Access Compliance Report

Public Rights-of-Way

(Curb Ramps)

Intersection ID: 27763	Main Street: BALLANTYNE_CROSSING_AV	Cross Street: BRICK_CHURCH_CT	Location: SW
ADA ID: 3C2471F7427D	Ramp Type: PerpDiag	Initial Pass/Fail: Fail	Overall Compliance: No
Severity Score: 8.75			
Codes/Mitigation Info/Possible Solution		Field Measurements/Component Compliance

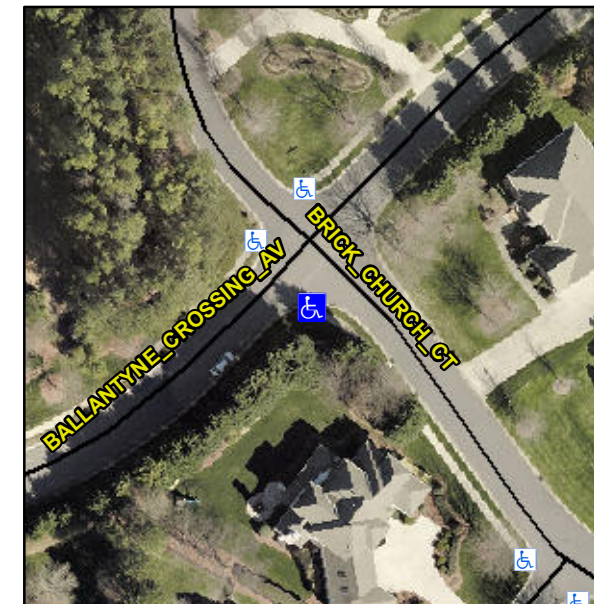
R304.5.1

Compliance	Description	Data	Compliance	Description	Data
N/A	Ramp Length (in)	50.0	Yes	Ramp Slope (%)	6.1
No	Ramp Width (in)	41.0	Yes	Ramp XSlope (%)	0.9
N/A	Flare Type LT	N/A	N/A	Flare Type RT	N/A
N/A	Flare Slope LT (%)	N/A	N/A	Flare Slope RT (%)	N/A
N/A	Flare Traversable LT?	N/A	N/A	Flare Traversable RT?	N/A
N/A	Landing Length (in)	N/A	N/A	DWS Provided?	N/A
N/A	Landing Width (in)	N/A	N/A	DWS Contrast?	N/A
N/A	Landing Slope (%)	N/A	N/A	DWS Length (in)	N/A
N/A	Landing X Slope (%)	N/A	N/A	DWS Full Width?	N/A
N/A	Landing Curb? (Y/N)	N/A	N/A	DWS Offset (in)	N/A
N/A	Shared Landing?	N/A			
N/A	Gutter Ponding?	N/A	N/A	Gutter Slope (%)	N/A
N/A	Gutter Lip Ht (in)	N/A	N/A	Gutter X Slope (%)	N/A
N/A	Painted X Walk1?	No	N/A	Painted X Walk2?	No
	X Walk 1 Direction	To NE		X Walk 2 Direction	To NW
N/A	X Walk 1 Width (in)	N/A	N/A	X Walk 2 Width (in)	N/A
	X Walk 1 Slope (%)	1.8		X Walk 2 Slope (%)	3.1
	X Walk 1 X Slope (%)	1.9		X Walk 2 X Slope (%)	2.1

Remove & Replace Curb Ramp With Two New Directional Ramps or Equivalent.
